Subject: Revised Limestone Aquifer Groundwater Assessment Work Plan for Delavan Spray Technologies Site

**RE: Revised Limestone Aquifer Groundwater Assessment Work Plan
Delavan Spray Technologies Site
Bamberg, South Carolina
SCDHEC VCC Number: 13-4762-RP
SCDHEC File Number: 51778
AECOM Project Number: 60314964**

TO: Regan Rahn, SCDHEC
FROM: Walter Gerald, AECOM
COPY: William Penn, UTC
 Leslee J. Alexander, AECOM
 AECOM Project File 60314964/60578249
RE: Revised Limestone Aquifer Groundwater Assessment Work Plan
 Delavan Spray LLC
 Bamberg, South Carolina
 VCC 13-4762-RP
DATE: August 27, 2018

FIGURE 1
PROPOSED MONITORING WELL LOCATIONS

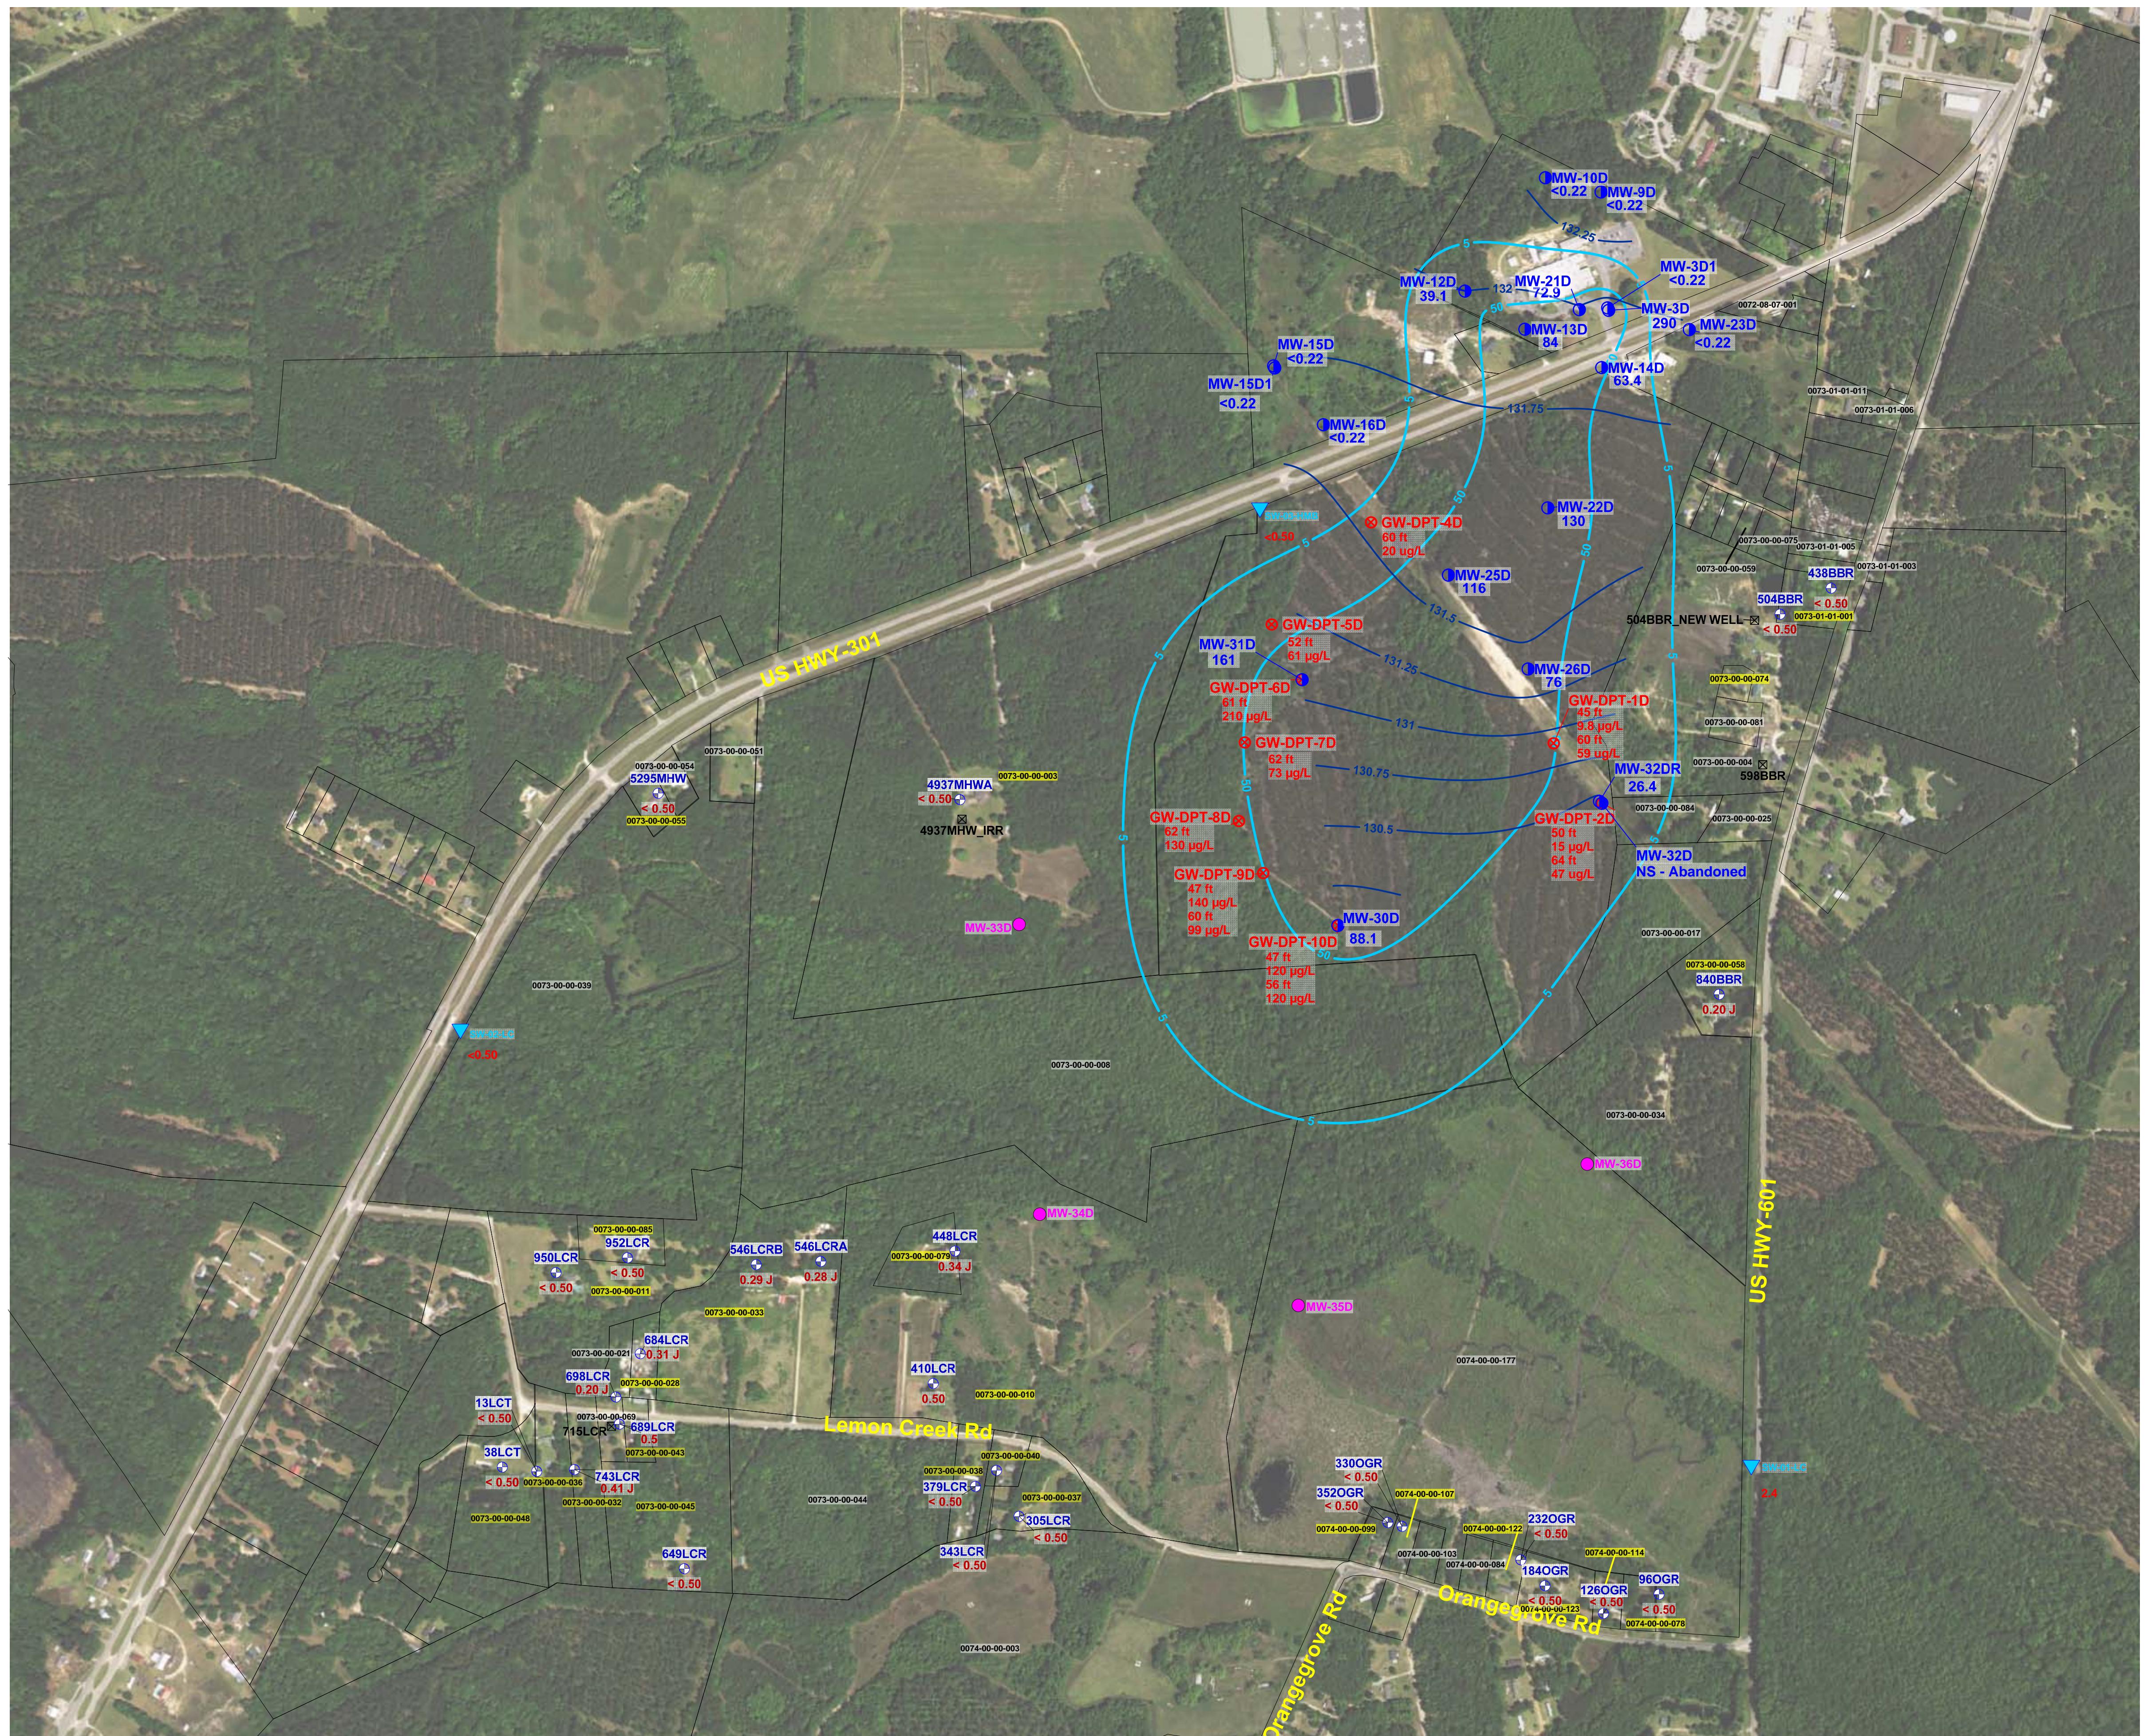
October 2017 PCE concentrations from limestone aquifer monitoring wells and PCE concentrations detected in residential well samples were contoured and are illustrated on Figure 1. Based on these data, four (4) deep limestone aquifer monitoring wells are proposed. These locations are expected to complete delineation of the PCE plume (Figure 1). Sonic drilling techniques are expected to be used to advance each boring to the target depth (e.g., a track-mounted Geoprobe® 8140LS sonic rig, or similar). However, other technologies may be used, if necessary, such as: DPT, hollow-stem auger or mud rotary. Boreholes will be logged in accordance with Section 2.3 of the *Limestone Aquifer Assessment Work Plan* (AECOM, 2017). Type III monitoring wells will be installed to depths of 50 to 75 feet below ground surface as described in Section 2.5 of the Work Plan and Attachment A of this Revised Work Plan.
